ADDENDUM NUMBER TWO

SWIM TEAM LOCKER ROOM RENOVATIONS
UNIVERSITY OF SOUTH CAROLINA
COLUMBIA, SOUTH CAROLINA

DATE OF ISSUE: May 12, 2014

DRAWING TITLE	DATE
ENLARGED PLANS AND INTERIOR ELEVATIONS	04.30.14
PROJECT NO.	DRAWING NO.
1032.13	A3.3R

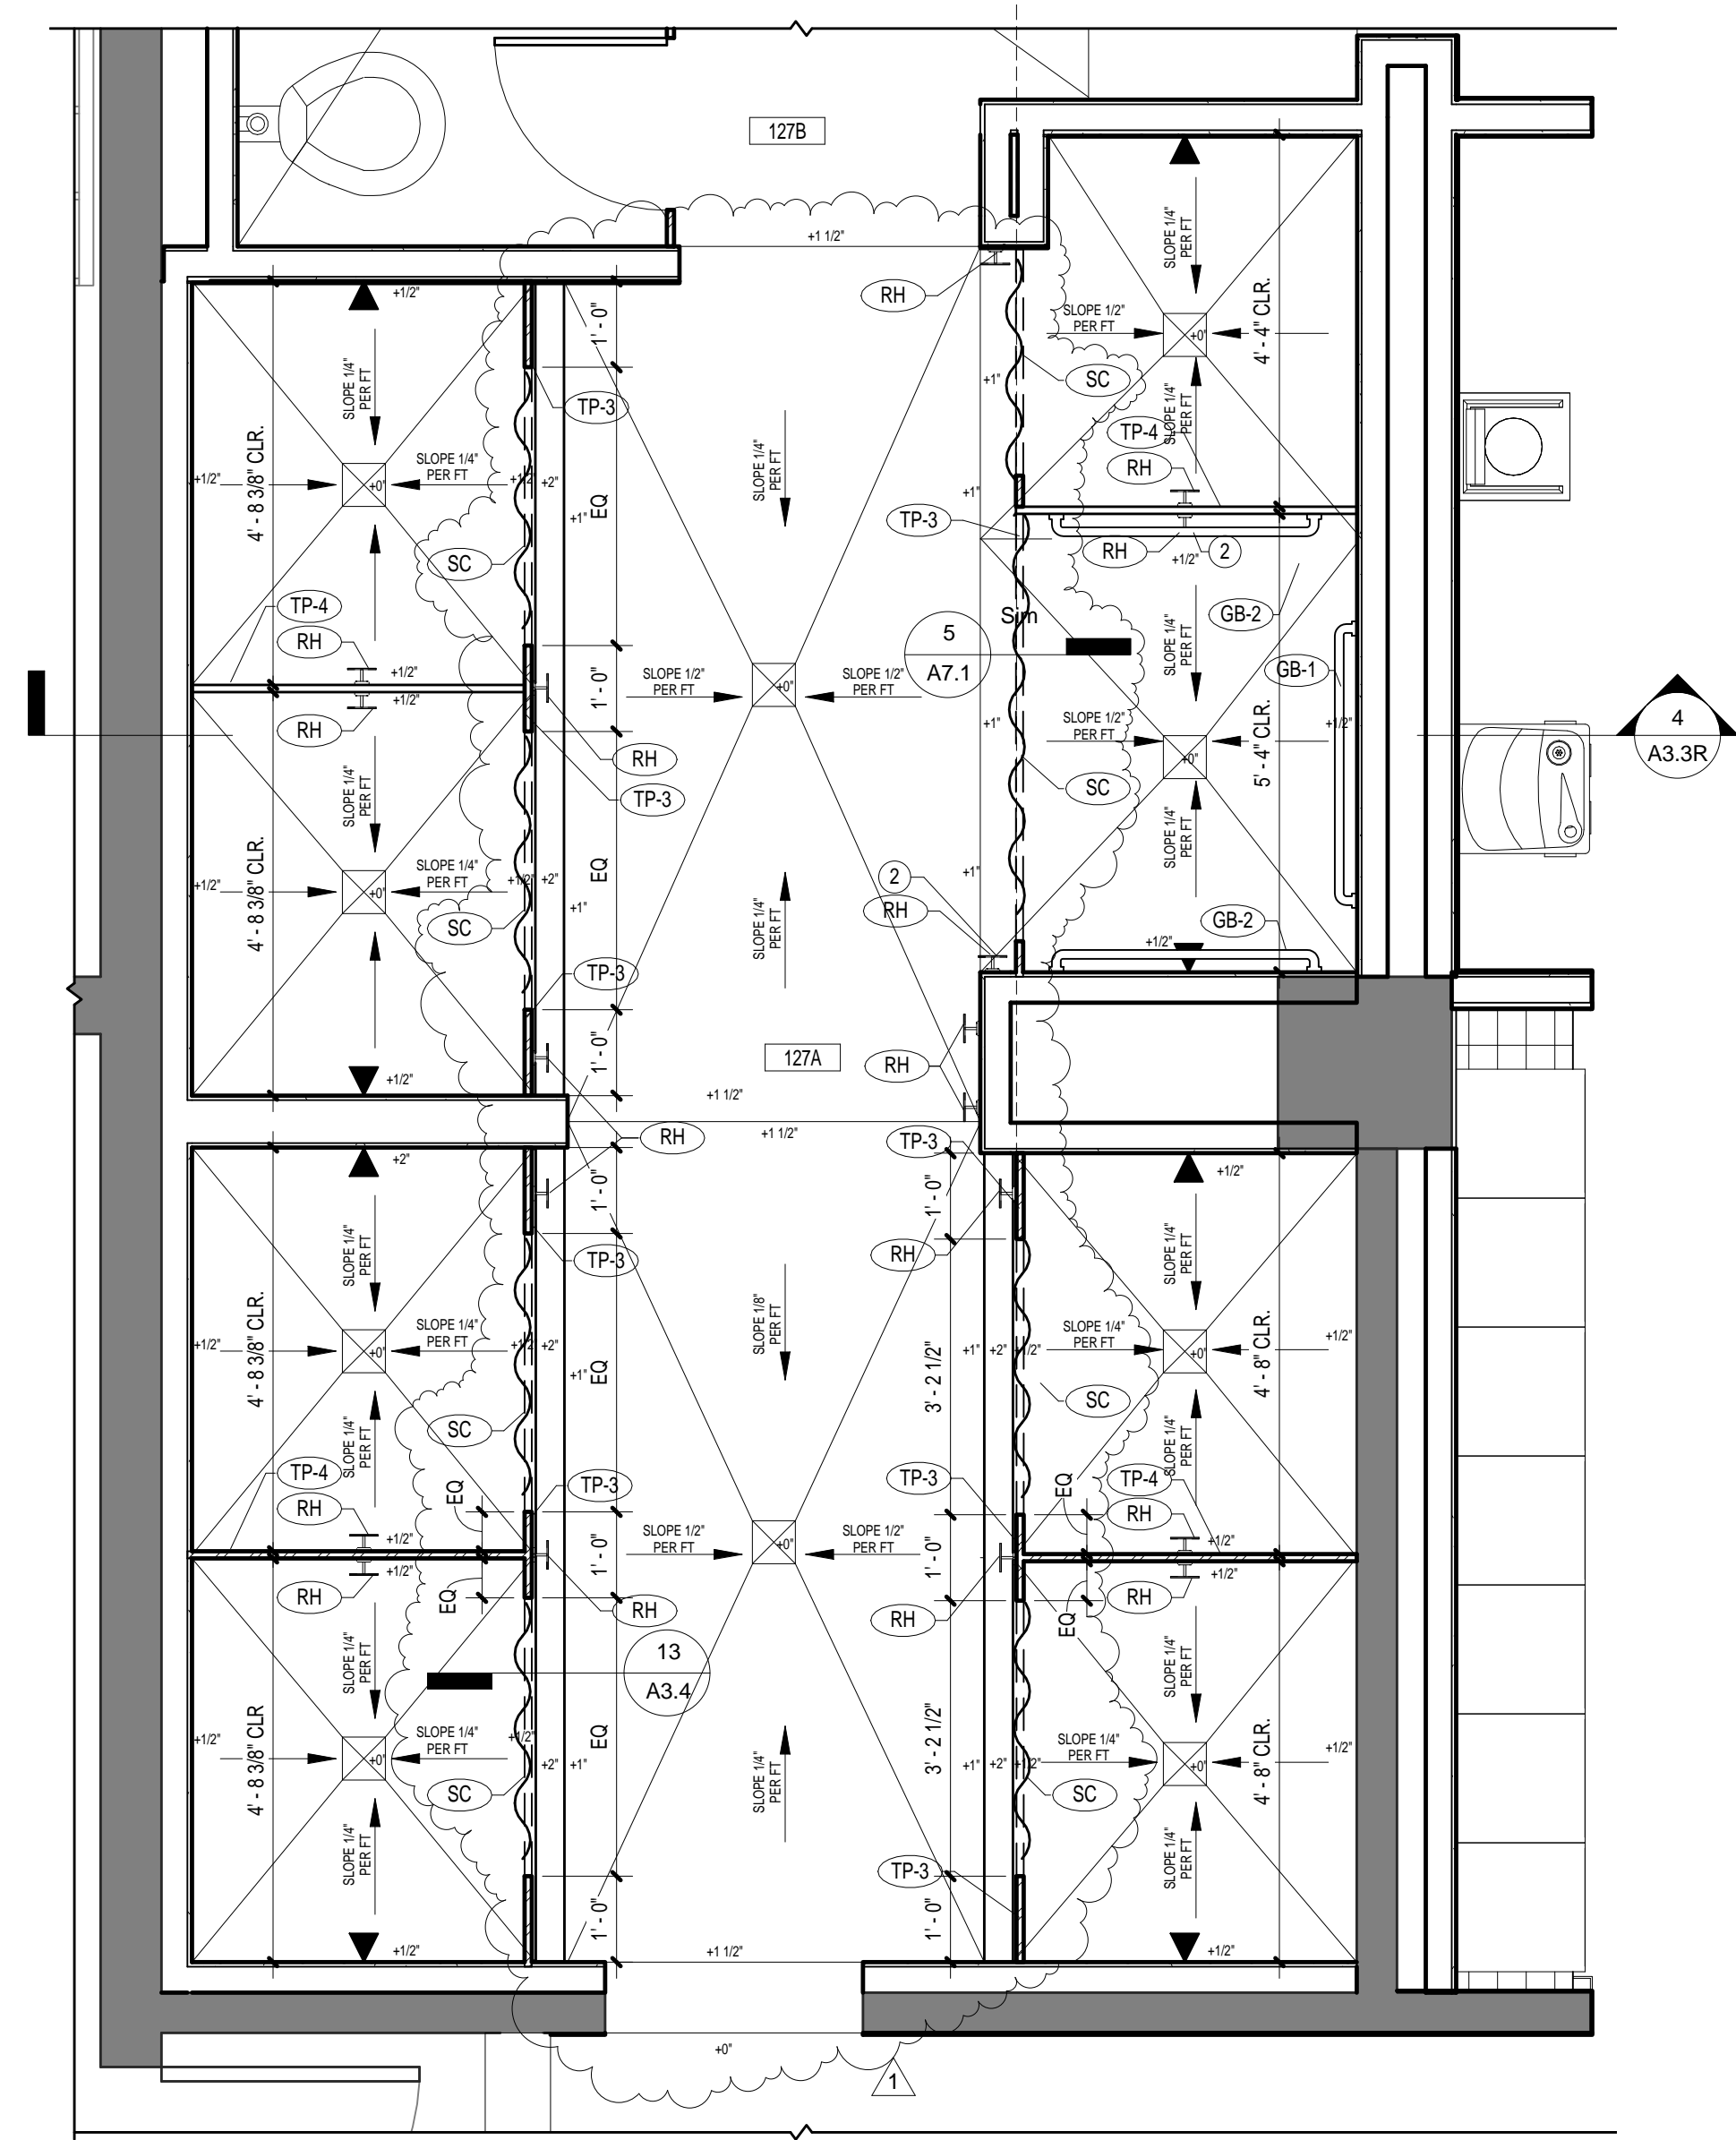
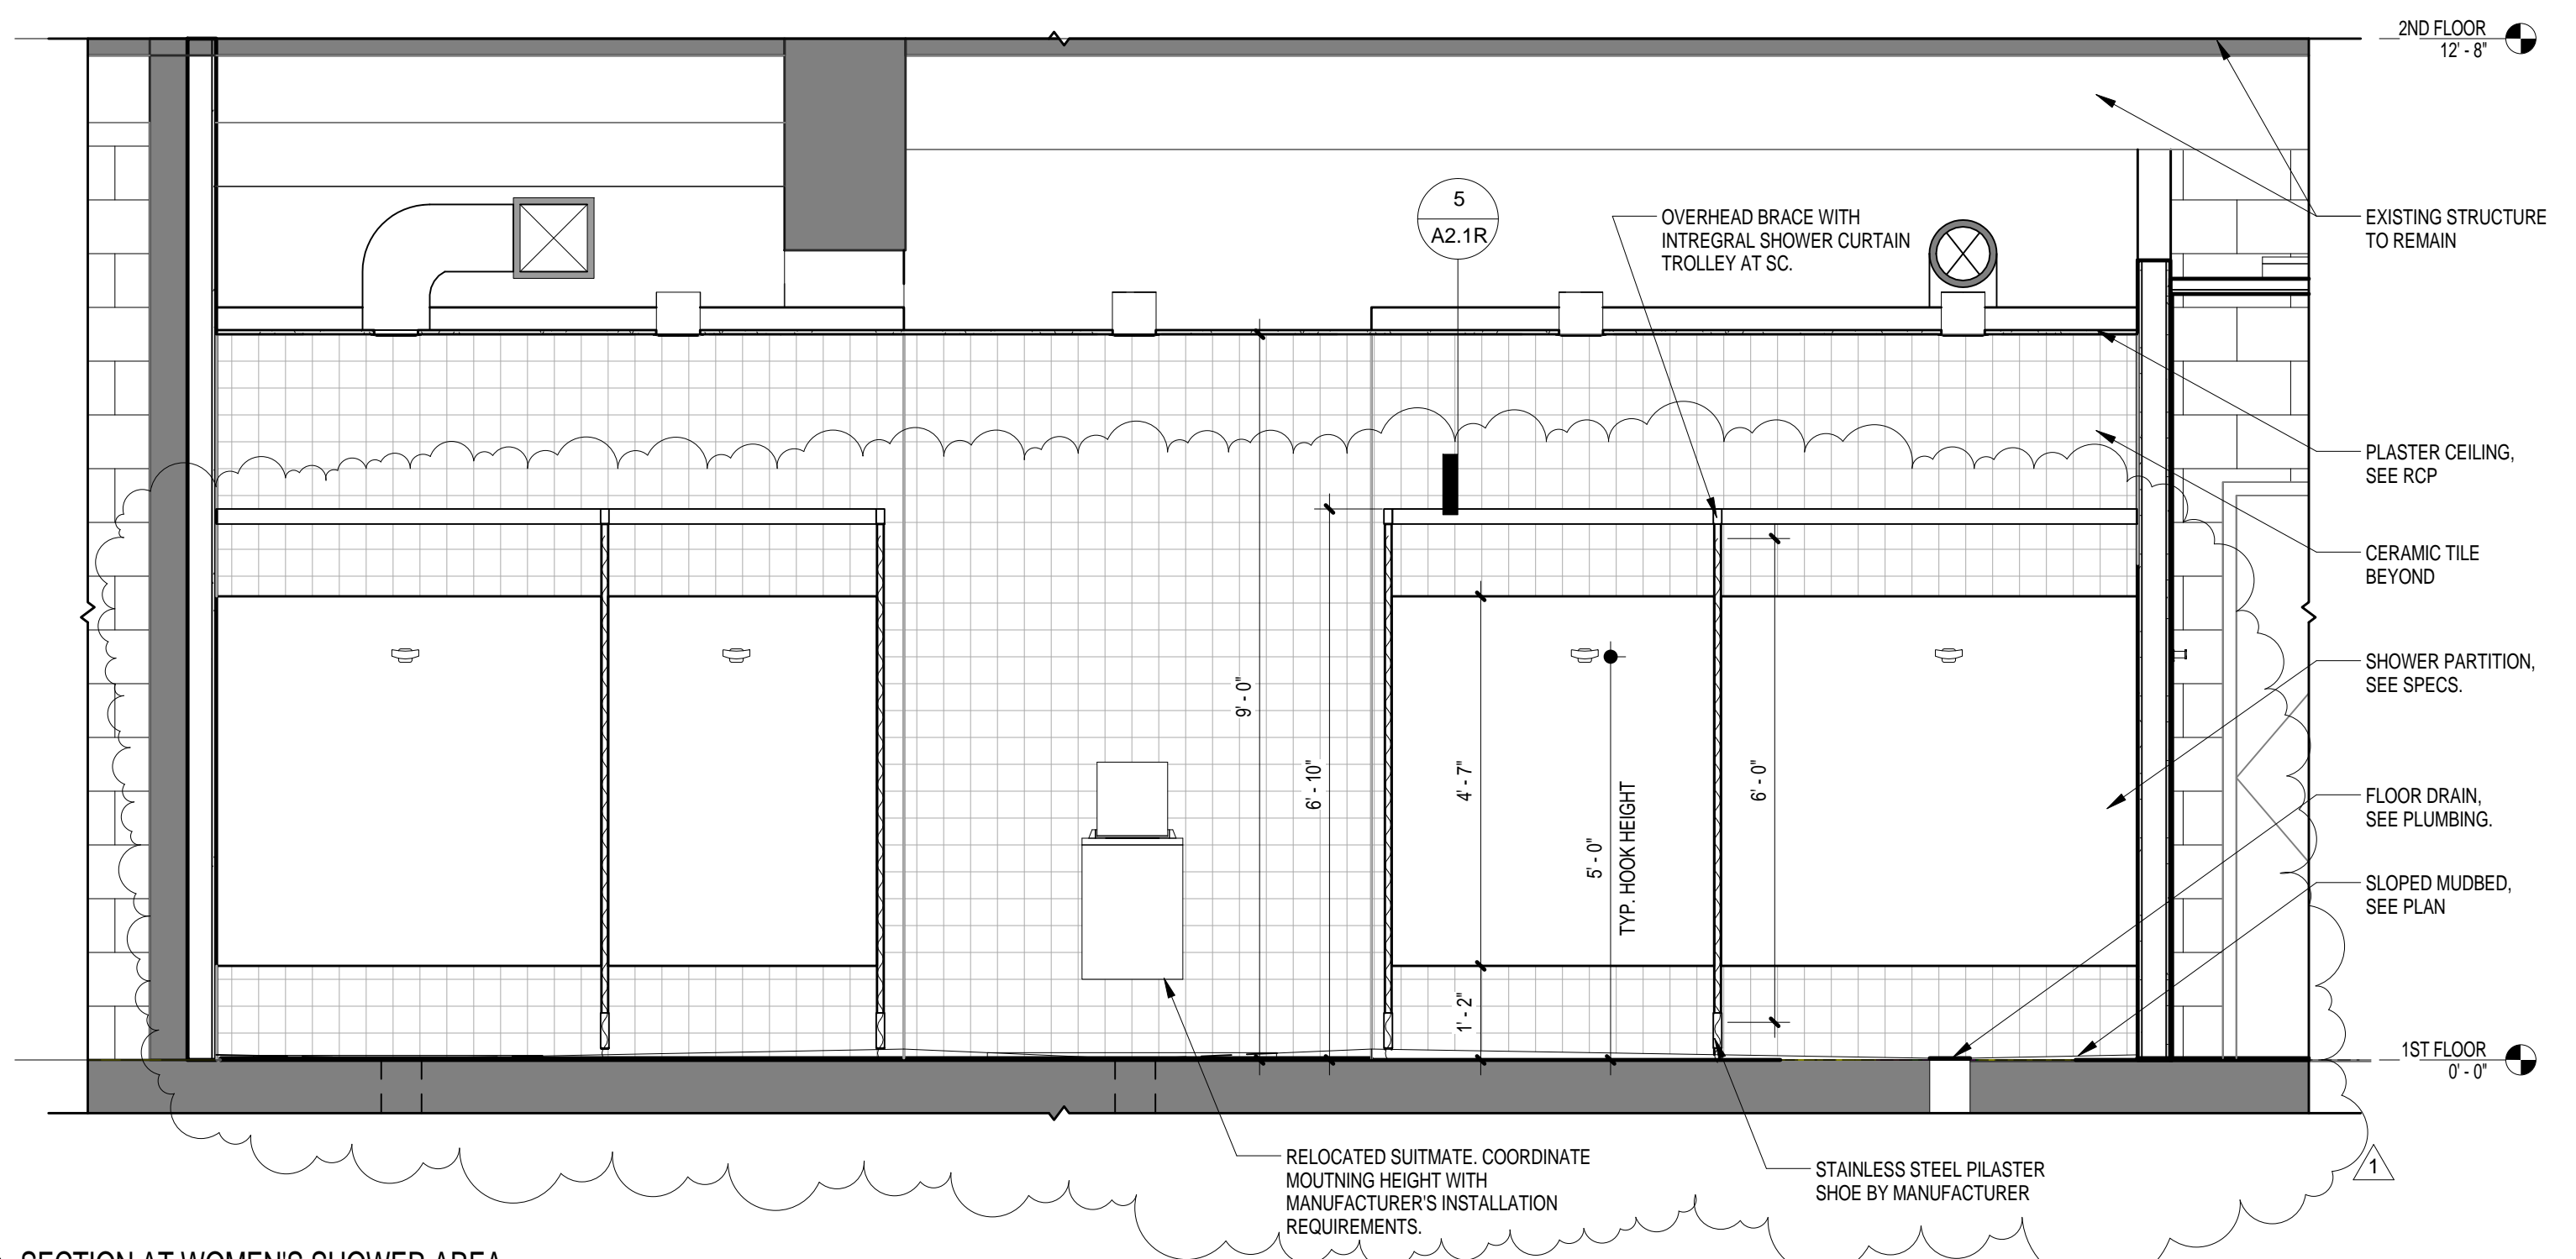
1. **Revision:** Delete Sheet A2.1 and E2.1 from Bid Documents. Replace with attached A2.1R and E2.1R. See revised base bid lighting layout in Women's Locker Room 136, Team Room 136F, and Men's Locker Room 127. See attached sketch SKE1 for light fixture schedule revisions.
2. **Revision:** Add Alternate No. 3 to Bid Documents. Add sheets A2.1A and E2.1A to Bid Documents. Provide Alternate No. 3 lighting layout in Women's Locker Room 136, Team Room 136F, and Men's Locker Room 127. See attached sketch SKE1 for light fixture schedule revisions.
3. **Revision:** Delete Sheet A3.3 from Bid Documents. Replace with attached A3.3R. See revised shower compartment/ shower curtain layouts and heights.
